Bid 622
**Rancho Campana High School HVAC Modernization Project for Oxnard
Union High School District**

ADDENDUM #2

Dated: June 12th, 2020

MHCFC4W-04-1 Wiring Diagram

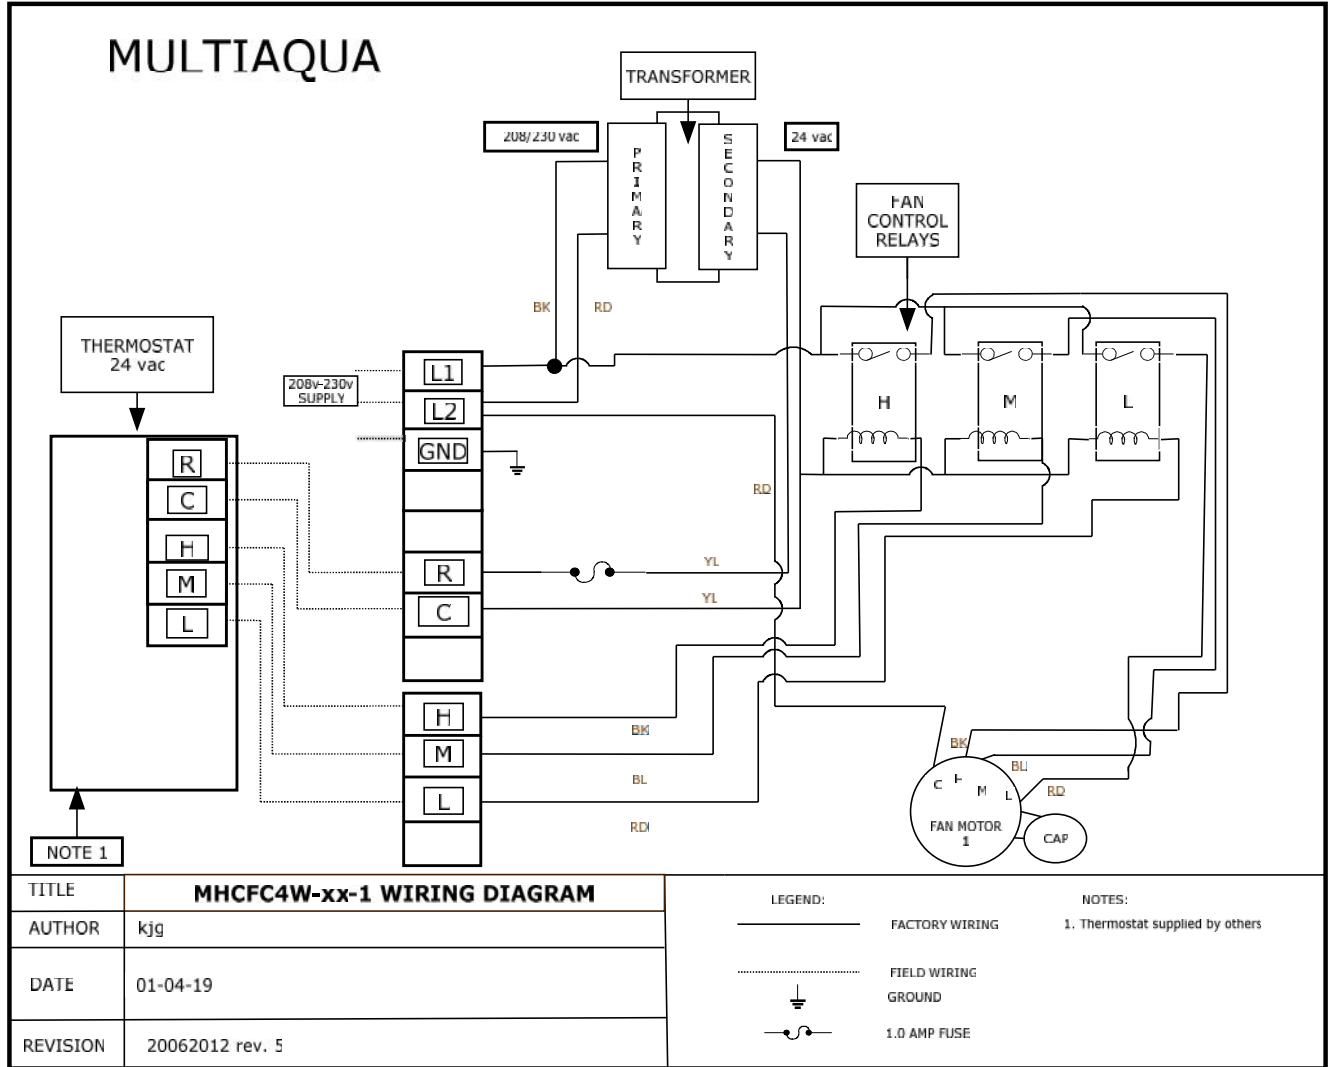
On the power plans, the cassette type FCU units show having (2) motor rated switches. The attached product data sheet for the scheduled equipment seems to indicate (1) is required. Please clarify as this seems as if it is an error on the drawings.

Provide (2) motor rated switches, (1) for FCU and (1) for condensate pump per plan.
Ali Hourai
Budlong and Associates

BUILDING E - ENLARGED HVAC ENCLOSURE PLAN
SCALE: 1/4" = 1'-0"

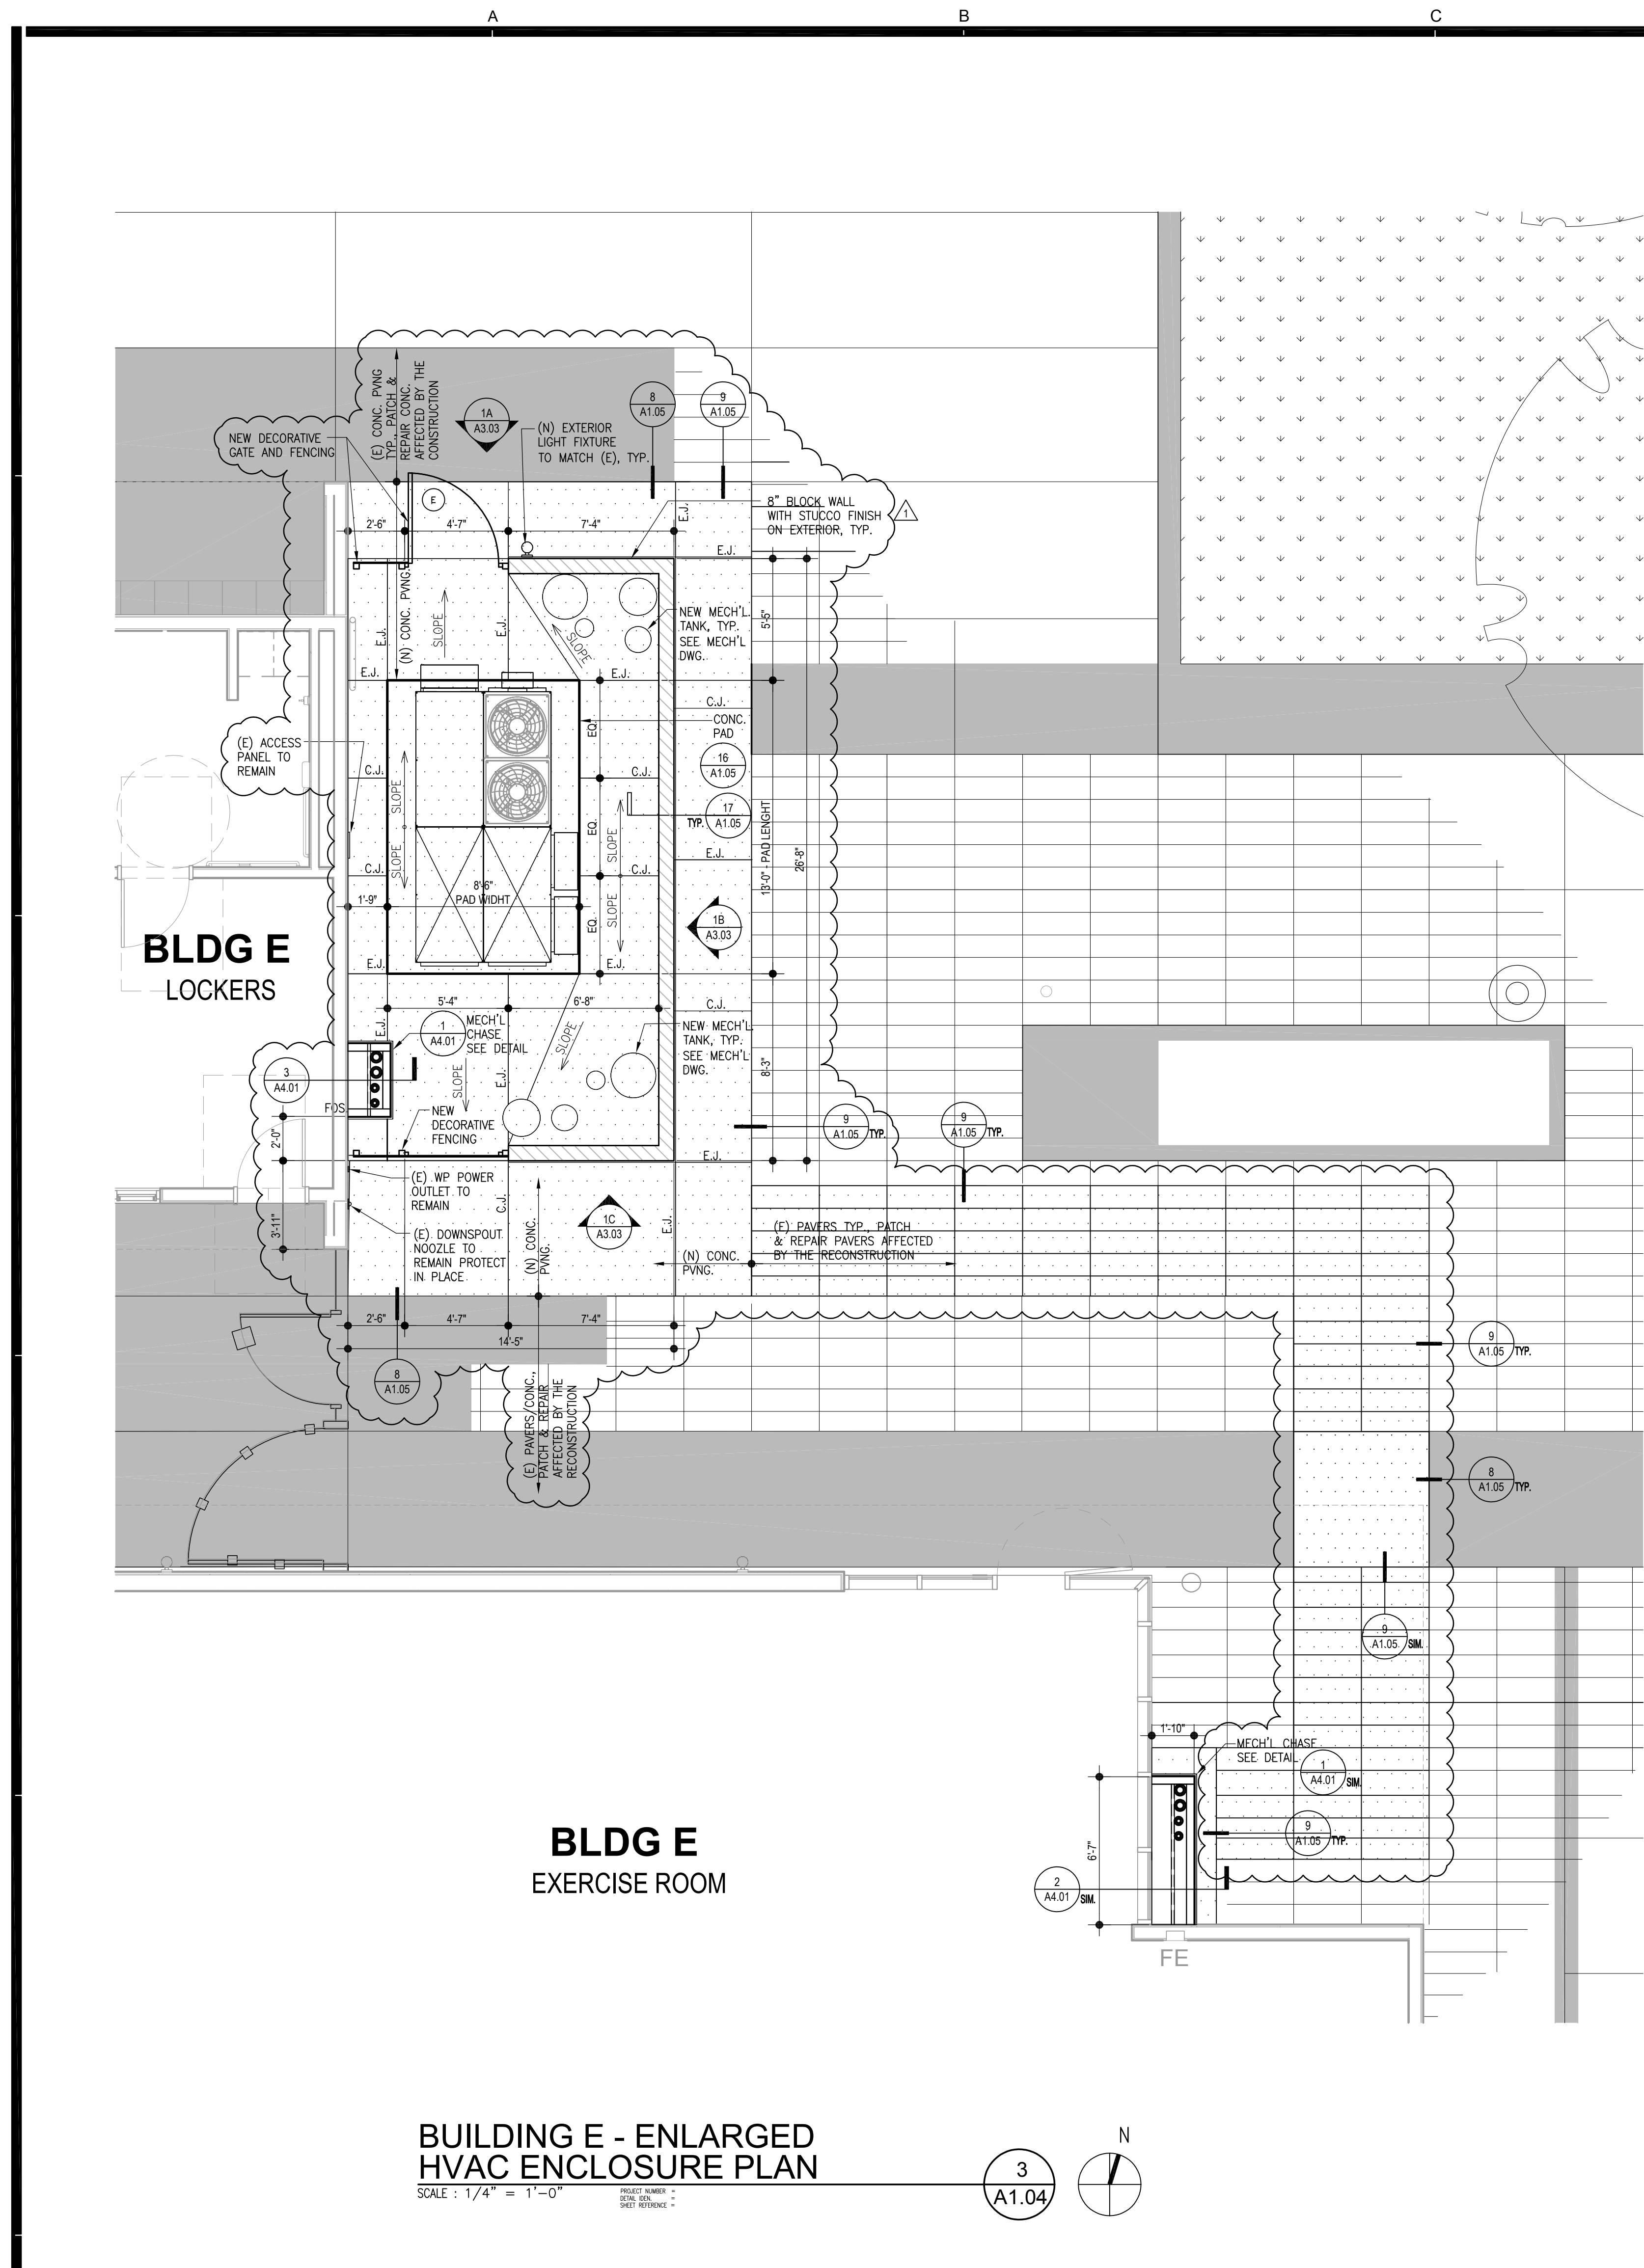
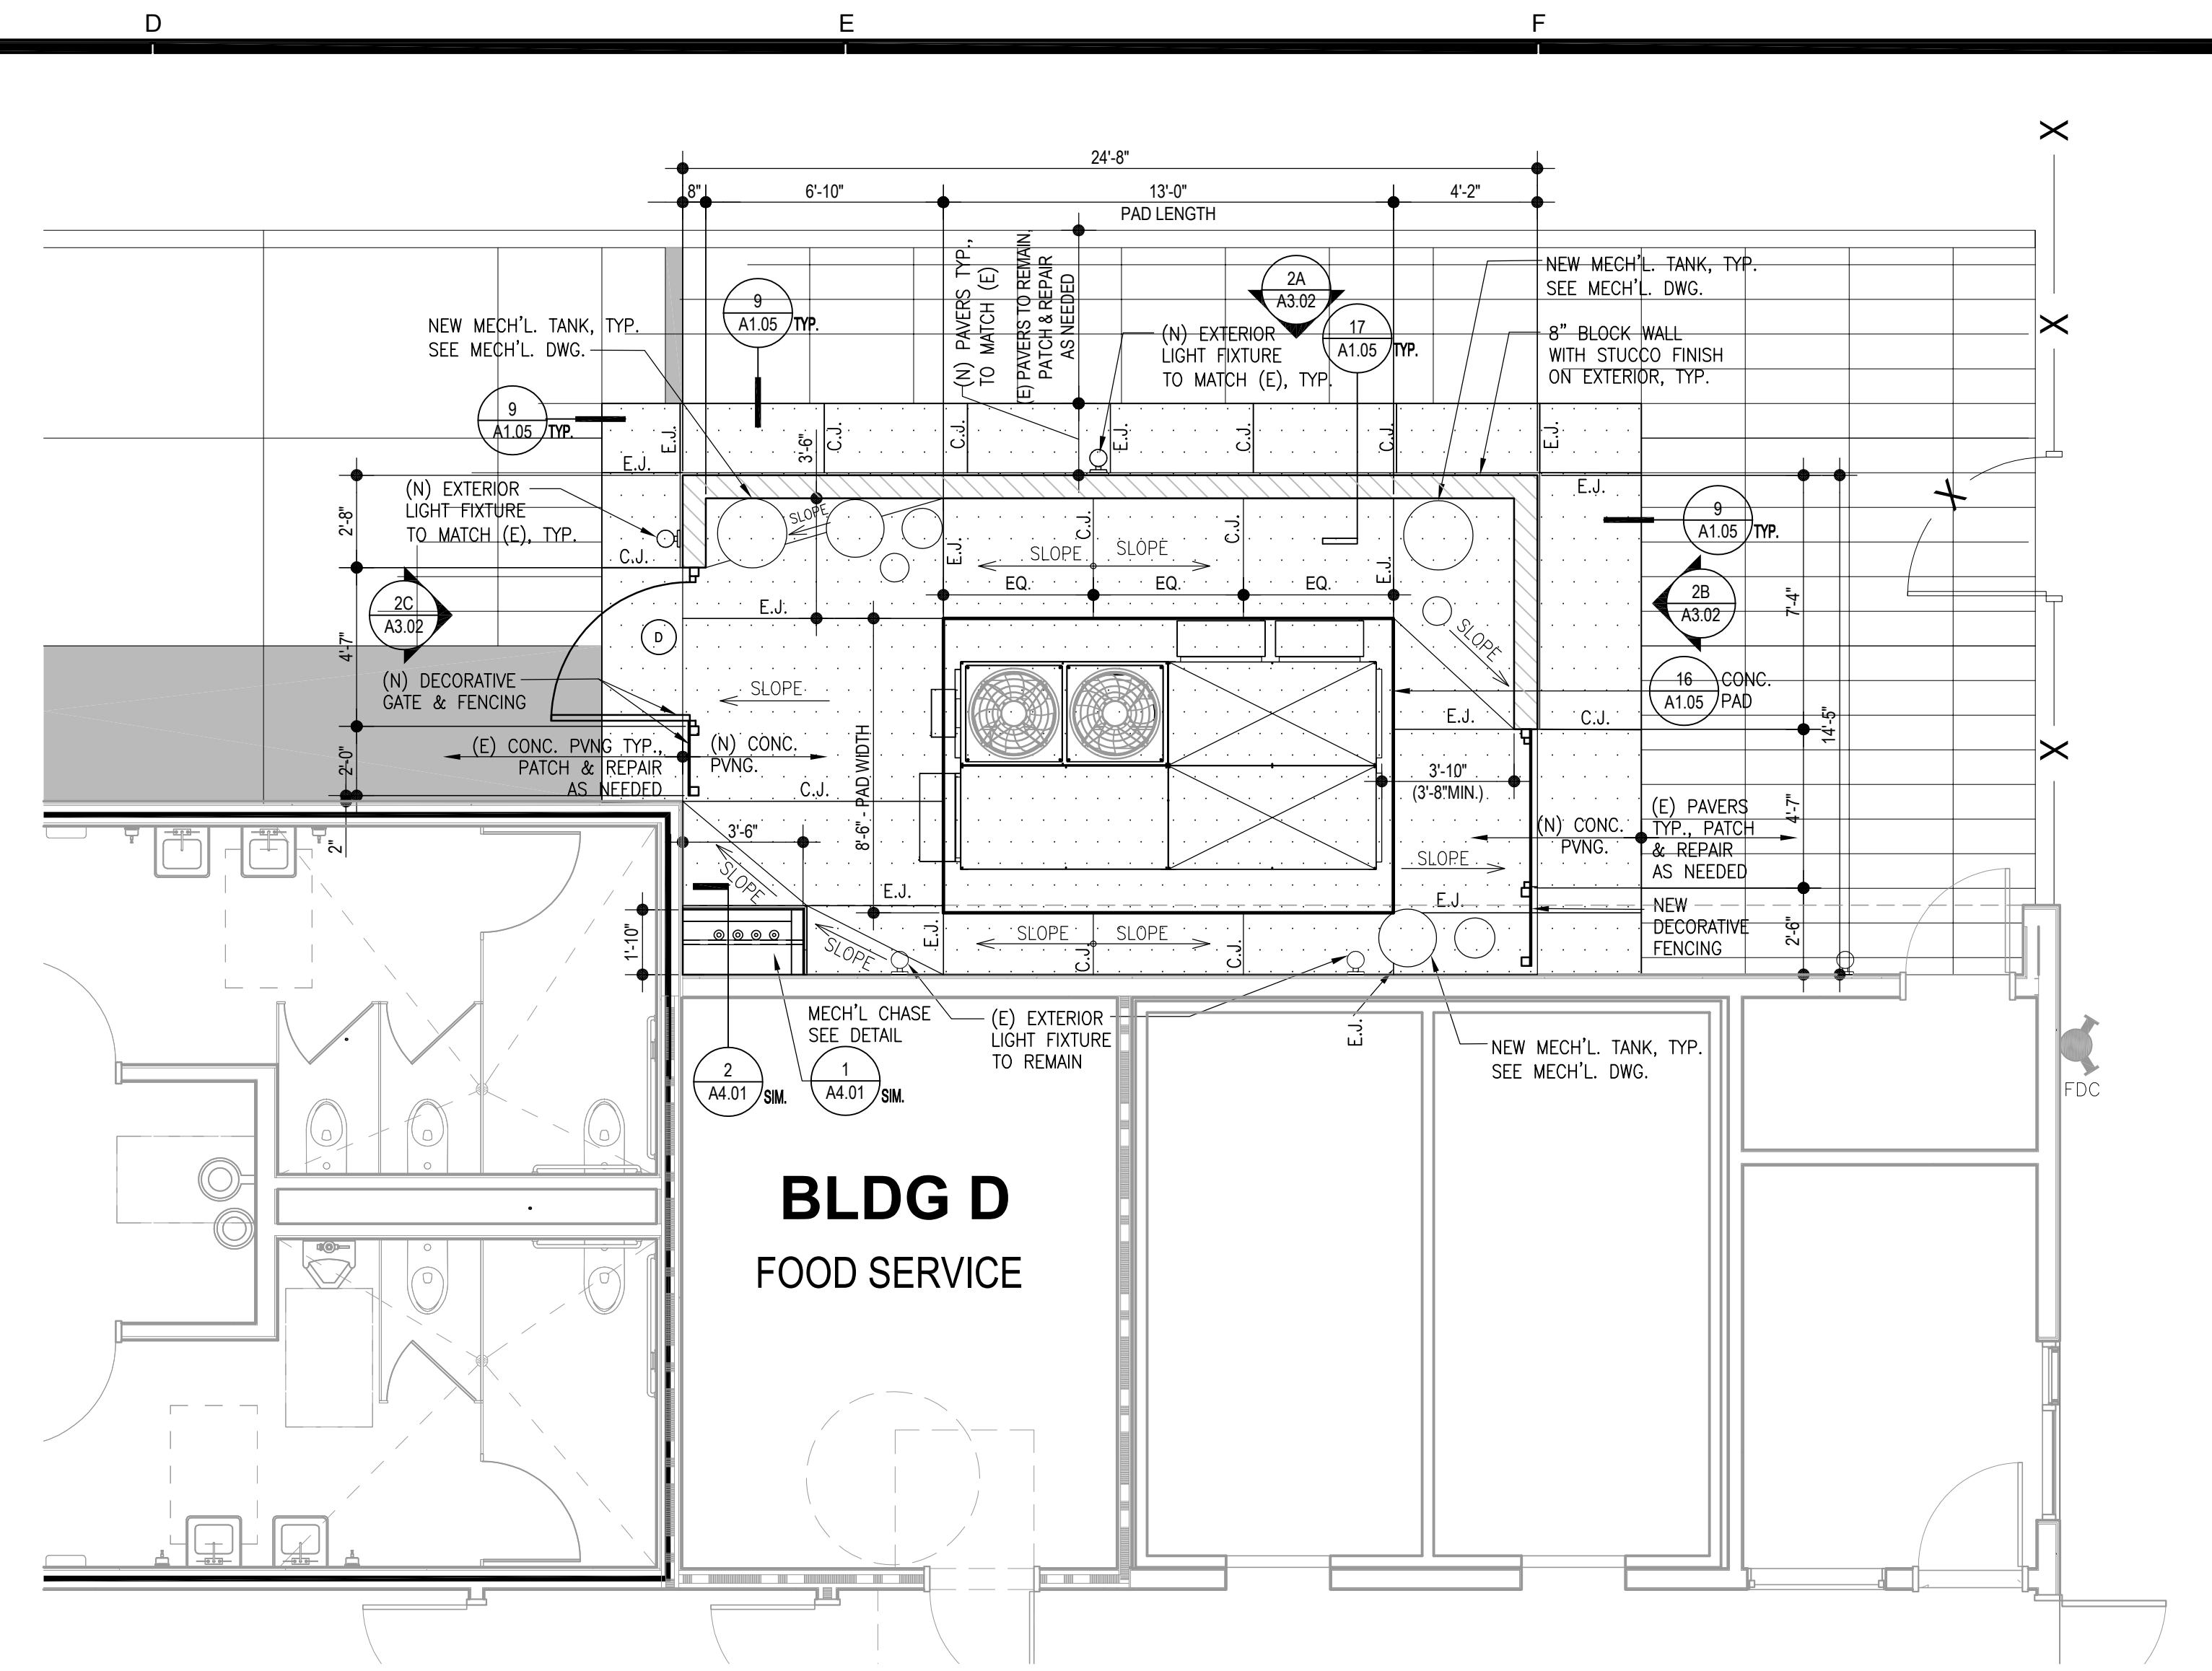
- 8) **Question: Los Angeles Air Conditioning, Inc. RFI #02 Referencing: Bldg. E piping enclosure drawing M4.03 at Grids (E-F) x (E-17.3).** At this location you have a glass window and we don't think the pipe will fit above this window. If this is your intent, please show a detail and direction on how to build this pipe chase alongside this window.

Referencing: Bldg. E piping enclosure drawing M4.03 at Grids (E-F) x (E-17.3)
At this location you have a glass window and we don't think the pipe will fit above this window.
If this is your intent, please show a detail and direction on how to build this pipe chase alongside this window?

New detail and information will be provided as part of Addendum to be issued. (See attachment I)
Sam Sahand - Flewelling & Moody - 06/05/2020.
